Appendix F  
*Storm Water Quality Management Plan*

CITY OF OCEANSIDE ENGINEERING DIVISION
<b>PRIORITY DEVELOPMENT PROJECT</b> <b>STORM WATER QUALITY MANAGEMENT PLAN</b> FOR Breeze Luxury Townhomes
ENGINEER OF WORK  _____ Ronald Holloway – RCE 29271 – 3-31-19

**RE: BREEZE LUXURY TOWNHOMES, T18-00009 – STORM WATER QUALITY  
MANAGEMENT PLAN – 1<sup>ST</sup> REVIEW RESPONSE**

**DRAINAGE MANAGEMENT  
AREA EXHIBIT  
BREEZE  
(LUXURY TOWNHOMES)**  
CITY OF OCEANSIDE, CALIFORNIA

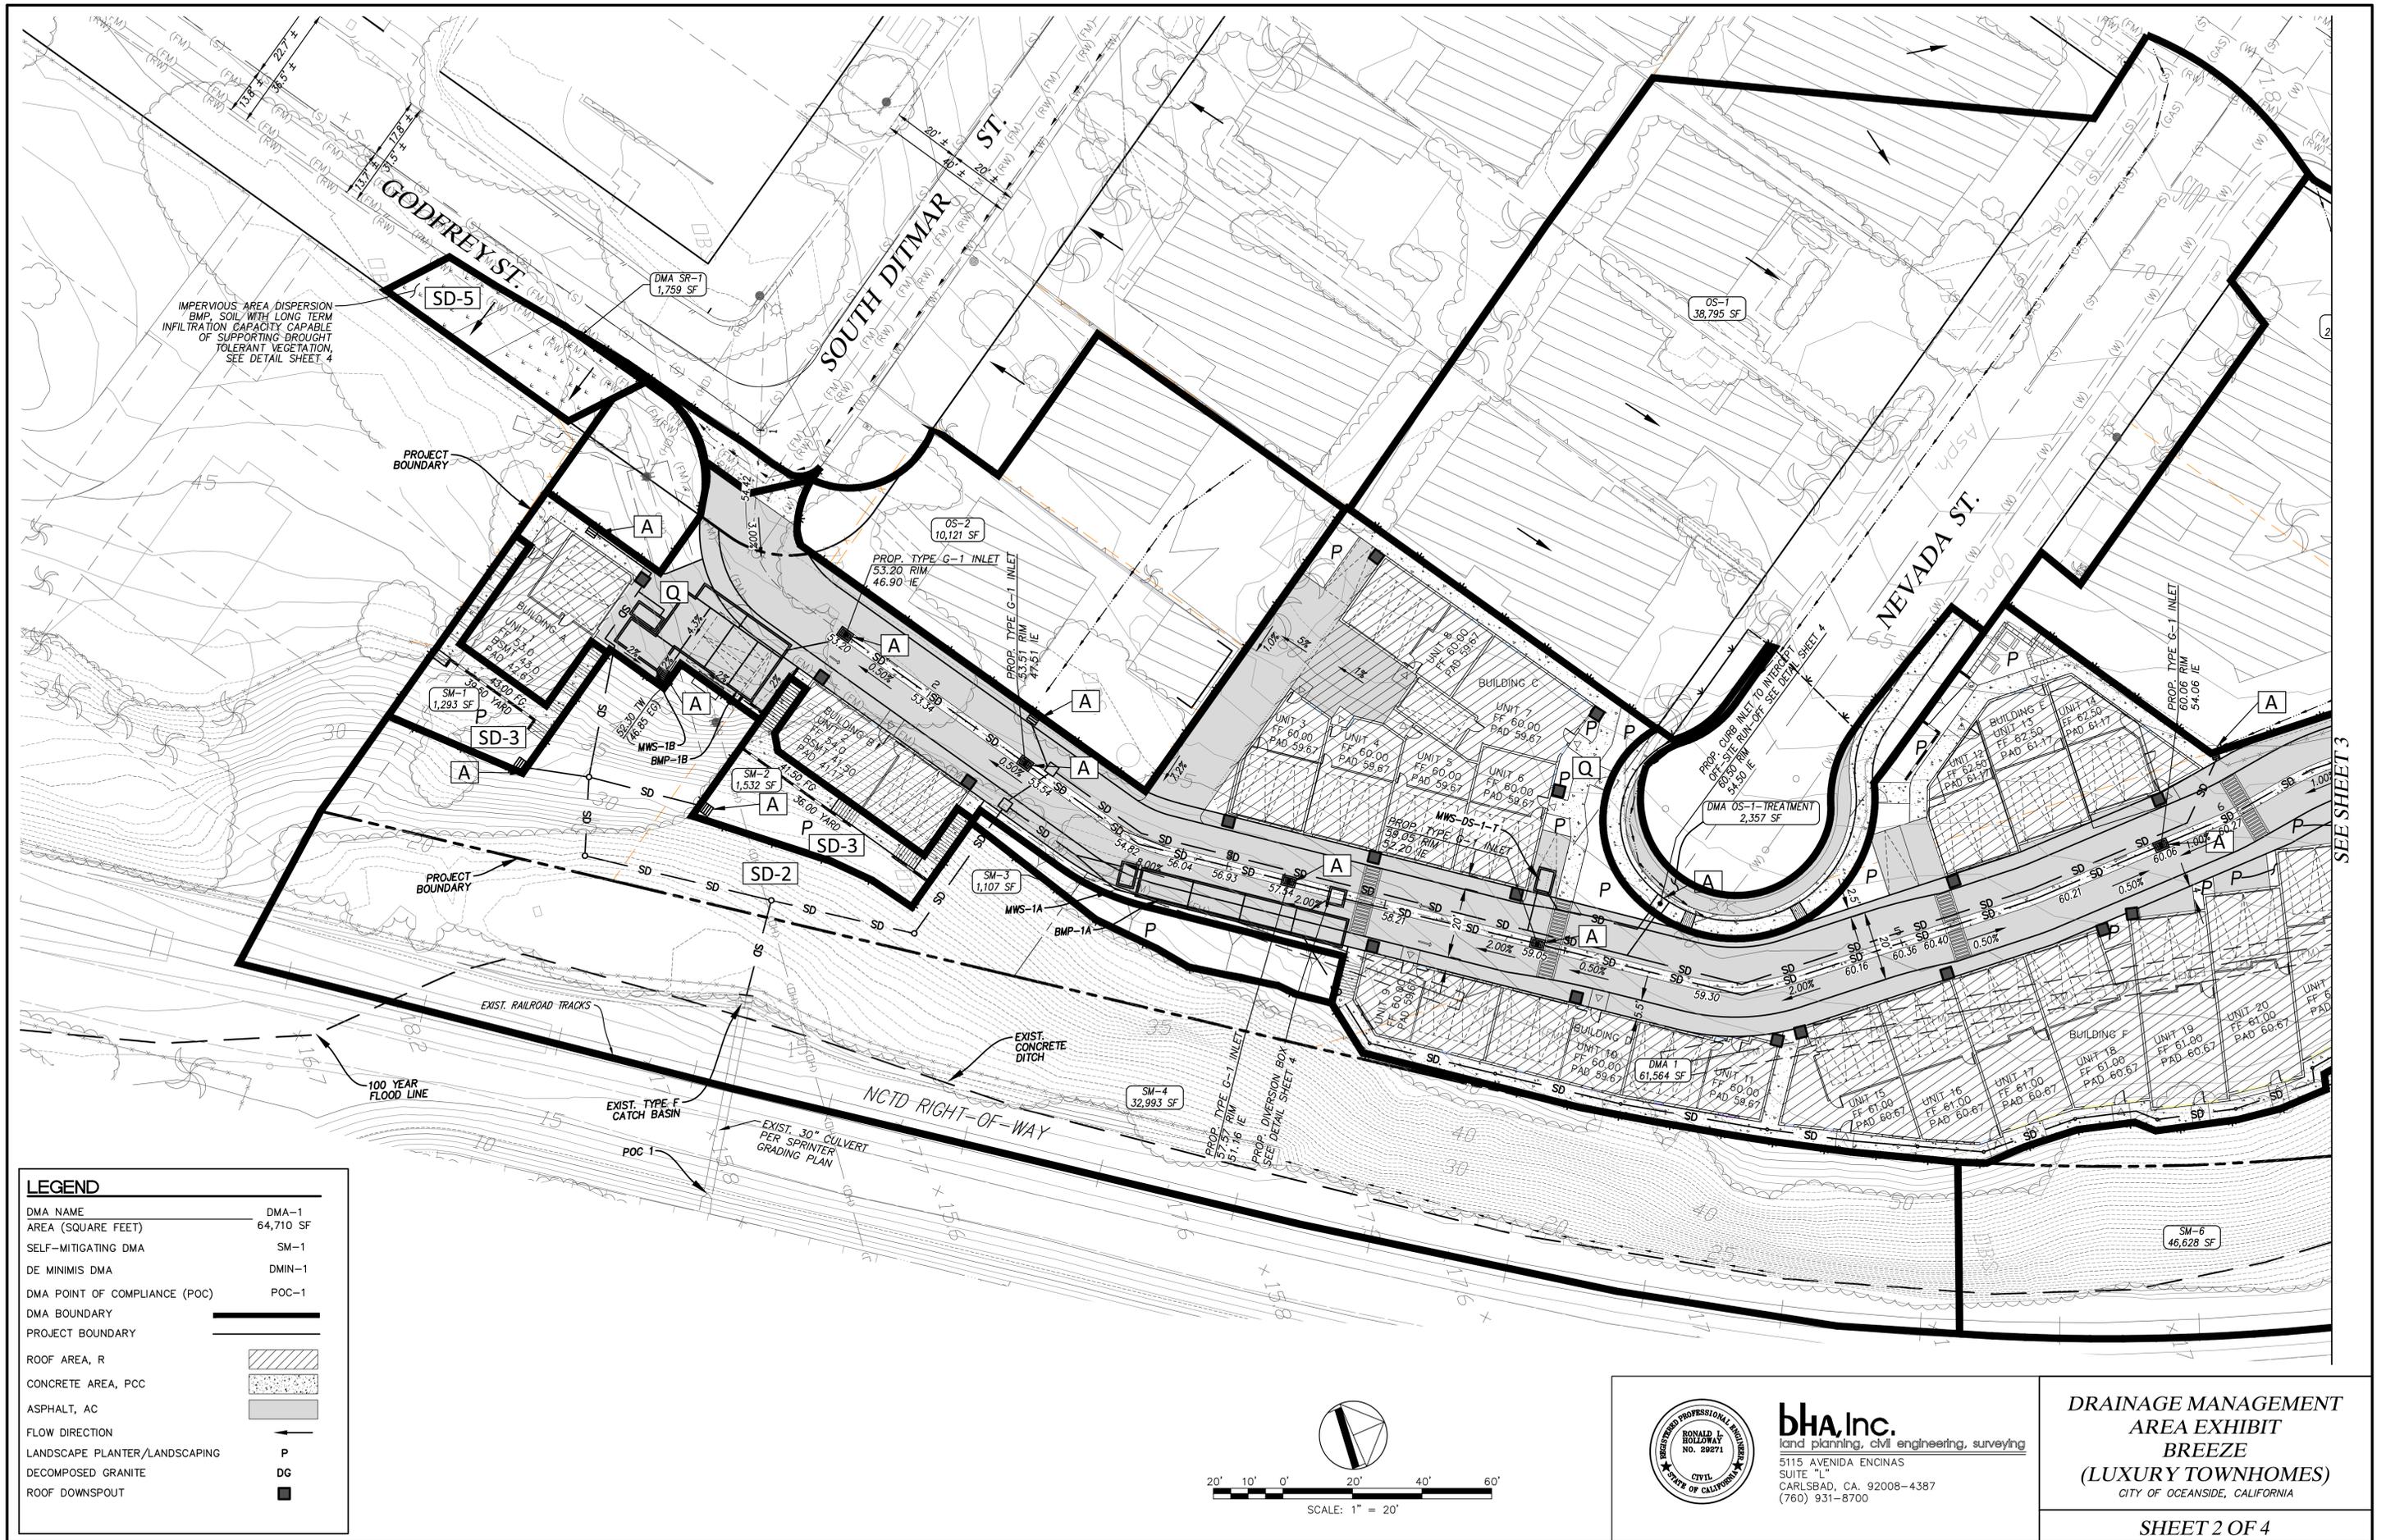
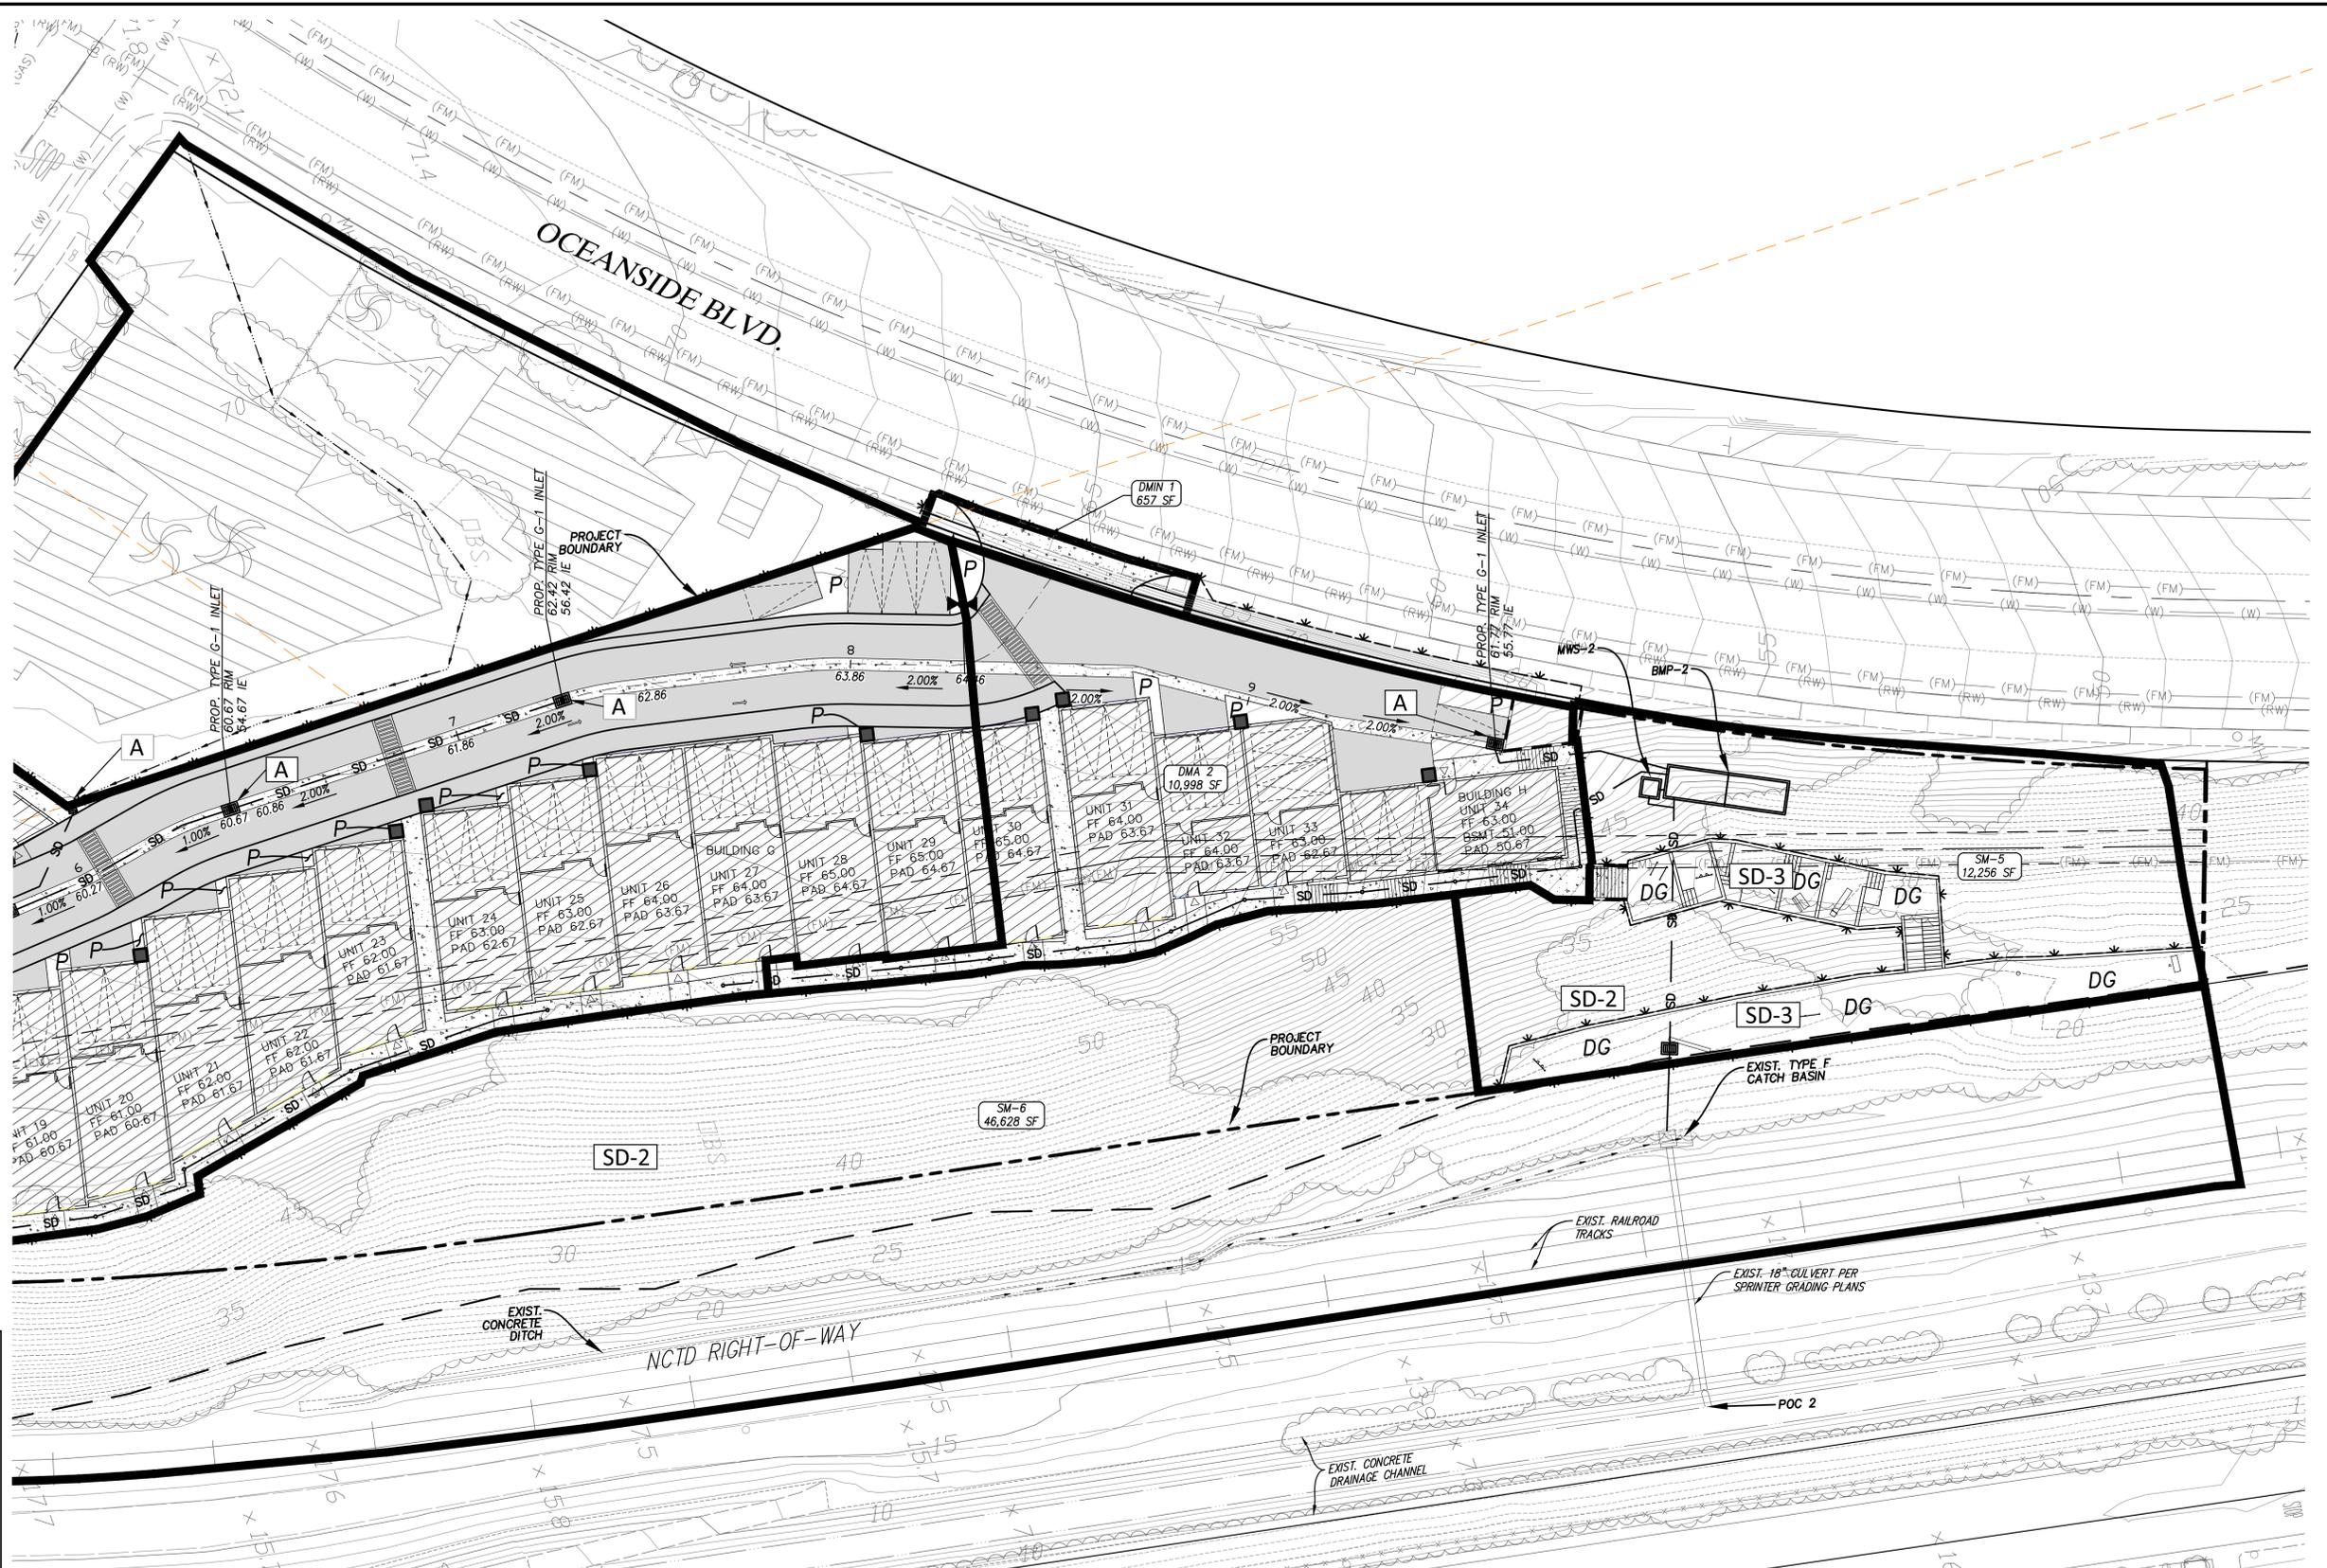
A. The DMA Exhibit is incomplete. Please address the following items and revise accordingly- using multiple sheets if necessary-and include a revised copy of the DMA Exhibit with the project grading plan sheets:

1. The BMP Exhibit does not show the following required elements:

*Have added topography and impervious areas within the development footprint.*

*See revised DMA Exhibit showing drainage network and roof down spout locations.*

*See revised DMA Exhibit showing pertinent elevations.*

*See revised DMA Exhibit showing distinguishable DMA boundaries.*
